**Vinich Development
Commercial Development Plan**

Planning Commission Meeting
February 2, 2025

Case Number: 25.01 DEV

Summary: The applicant is proposing to construct additions to an existing commercial shop building. The existing building is approximately 3,750 sf in size and the application proposes future additions of 3,600 sf on the north side of the existing structure and a second addition of 1,710 sf on the south side.

SITE PLAN FOR

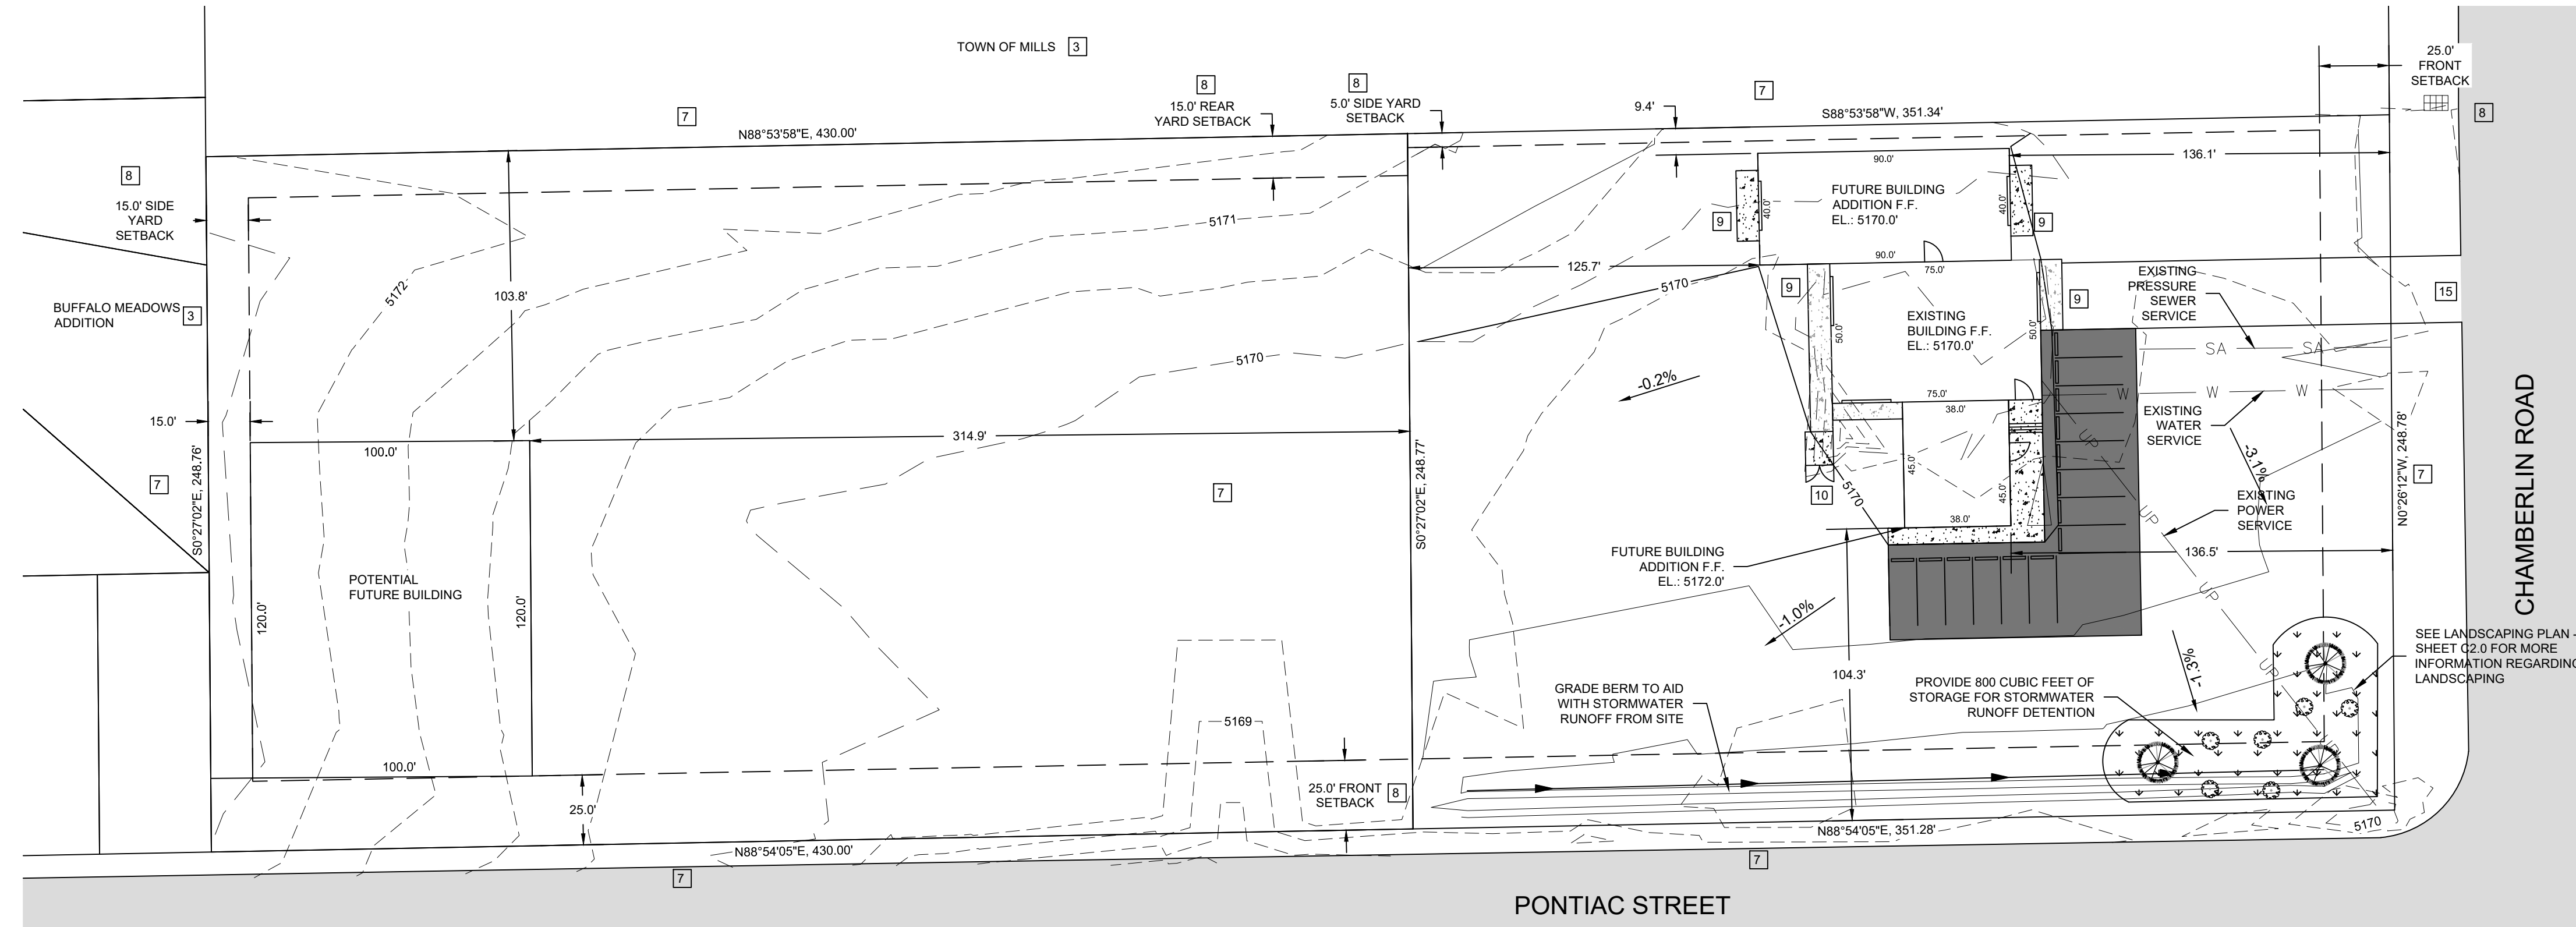
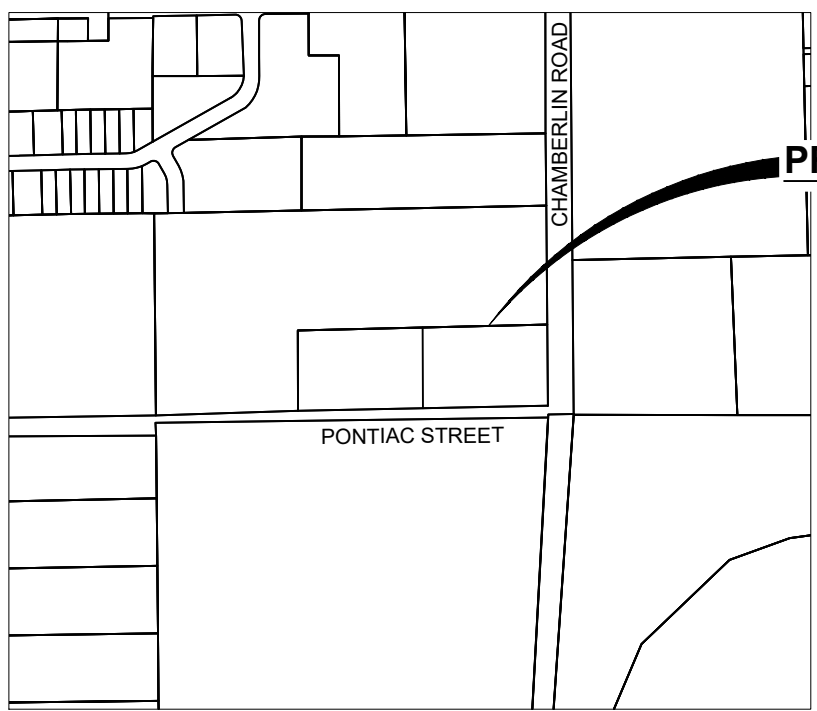
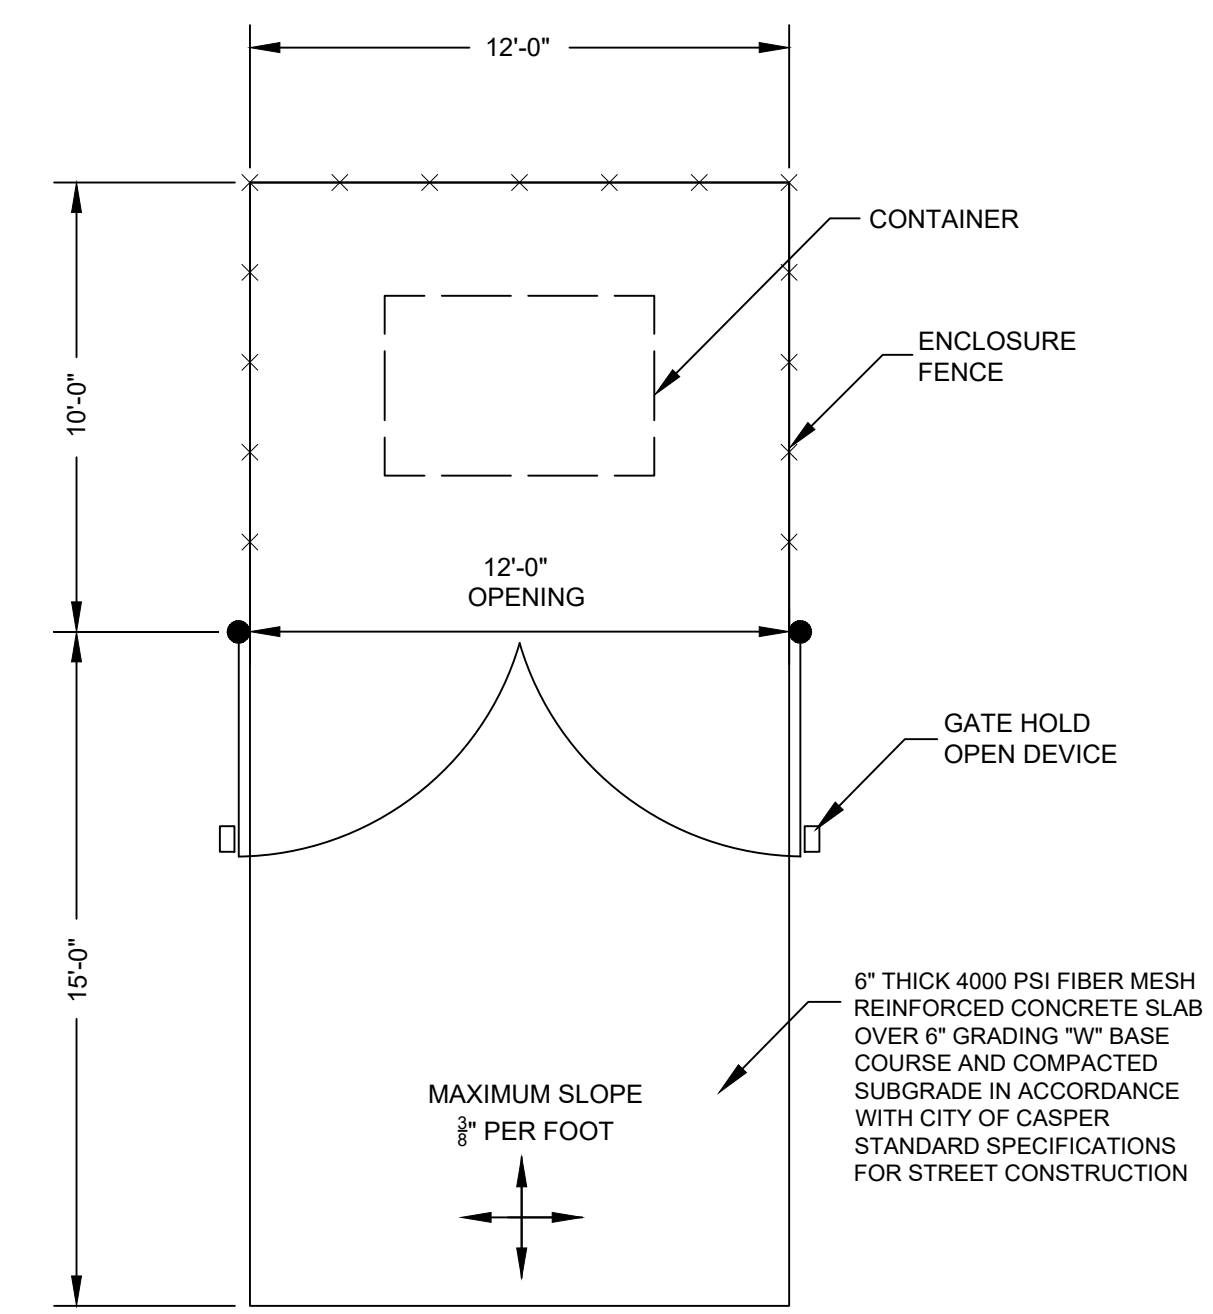
plan for the property has been included with the submittal. The development plan notes that exterior lighting will be on the building, with no proposed parking lot illumination. Specifications for the types of exterior lighting for the building need to be provided.

A 'potential future building' is depicted on the adjacent Lot 3A. It should be noted that any future development on Lot 3A will require a separate Development Plan application and review. The applicant should also be aware of additional setbacks and buffering that will be required for commercial or industrial development adjacent to the residential Buffalo Meadows Addition.

1. Submit an exterior lighting plan per Section 40.35(4) showing the location and types of lighting for the building, along with manufacturer's specifications.
2. Per Section 40.10(6) all required parking spaces and all driveways, entrances and exits from the parking area shall be paved with asphalt, concrete or similar permanent surface.
 - a. Nine (9) parking spaces are required. 14 are shown on the development plan with asphalt surfacing. This meets the intent of the regulations.
3. Submit a final drainage plan
4. Enter into an approved Site Plan Agreement upon approval of the Development Plan.
5. Obtain all required building permits for:
 - a. All site lighting
 - b. All on-premise signage.

LANDSCAPE PLAN FOR LOTS 2 AND 3, SAGE ADDITION

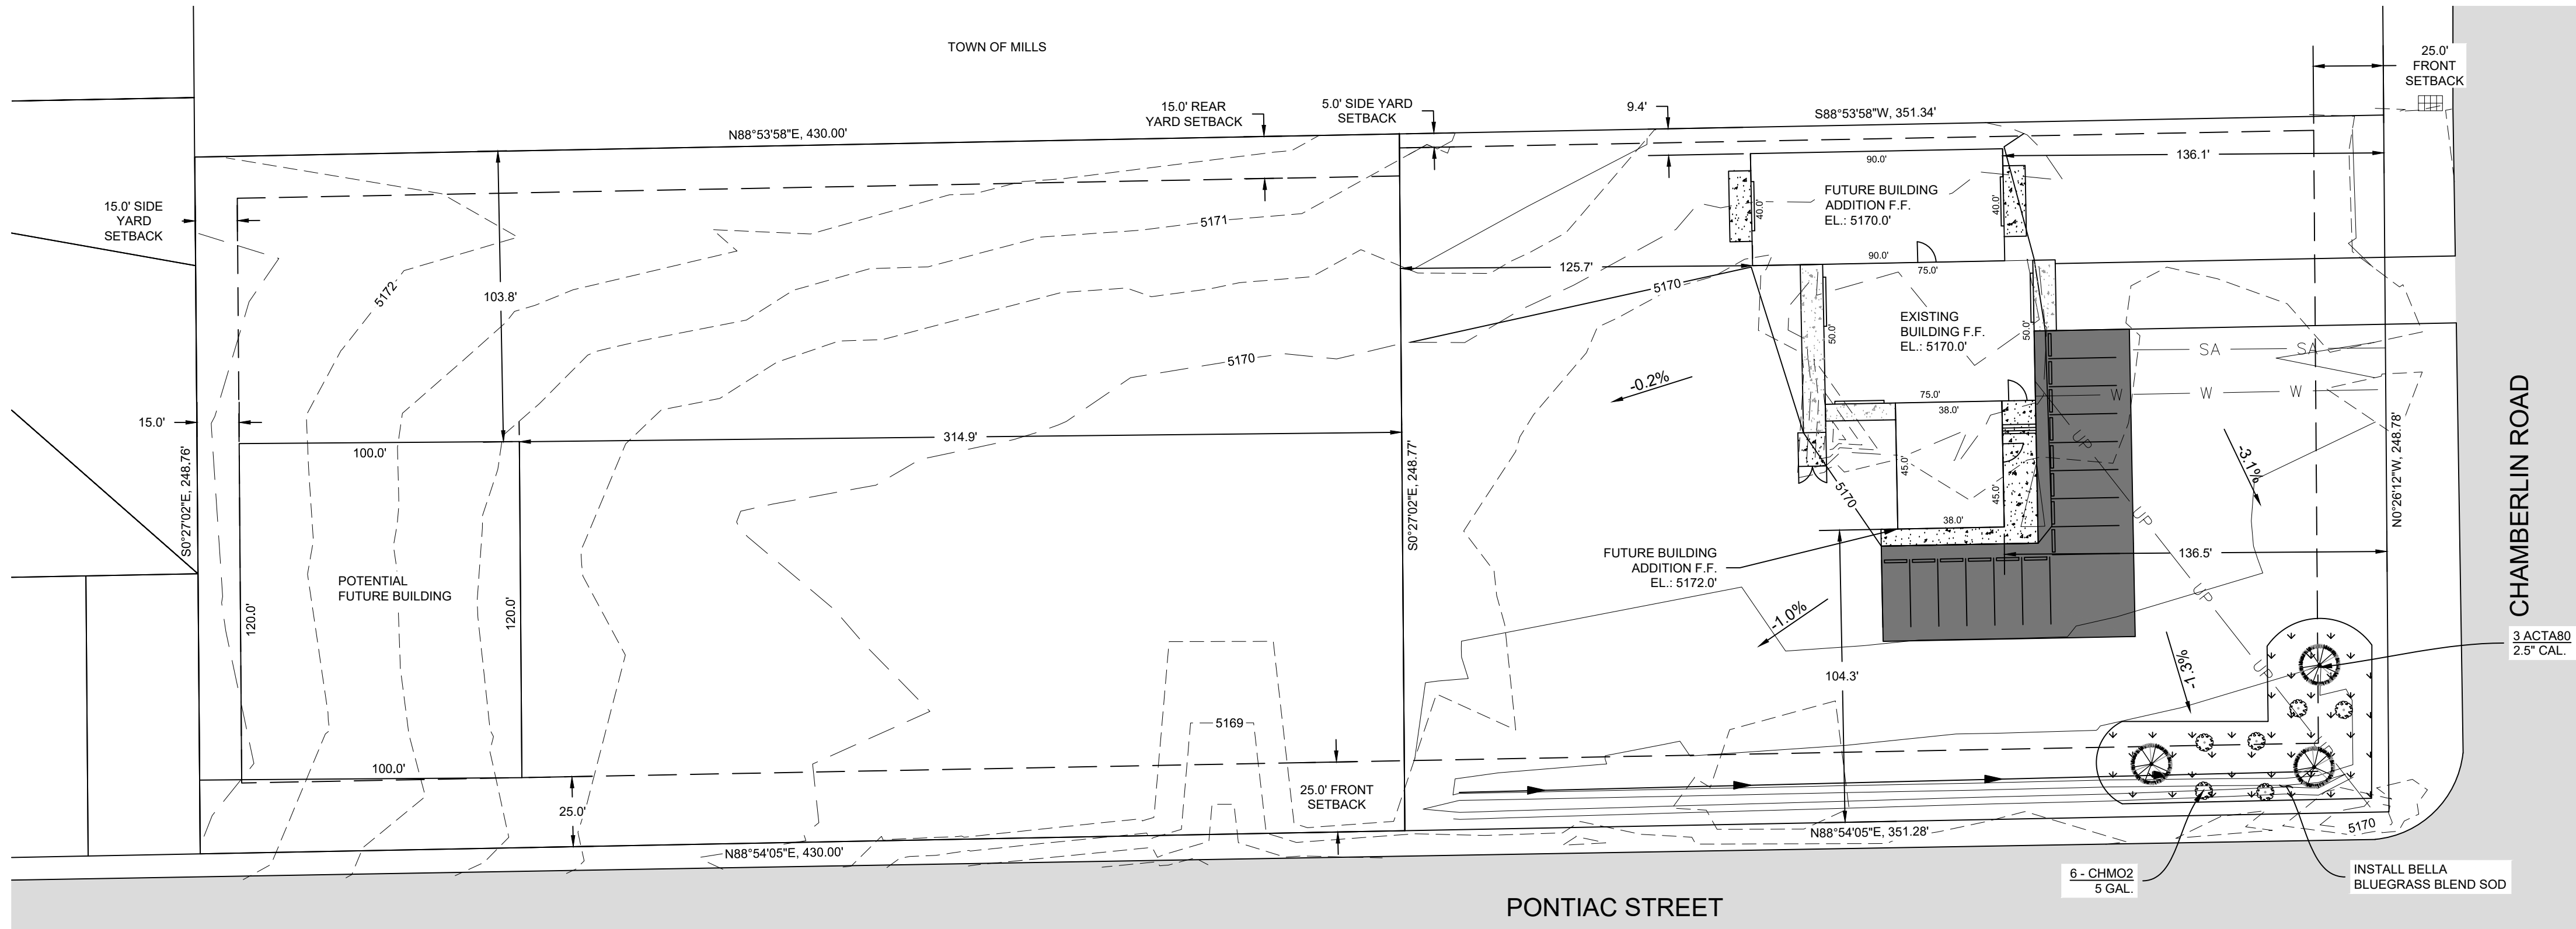
Per Section 40.40 of the LDRs, a minimum of 4% of the site must be landscaped. A landscaping
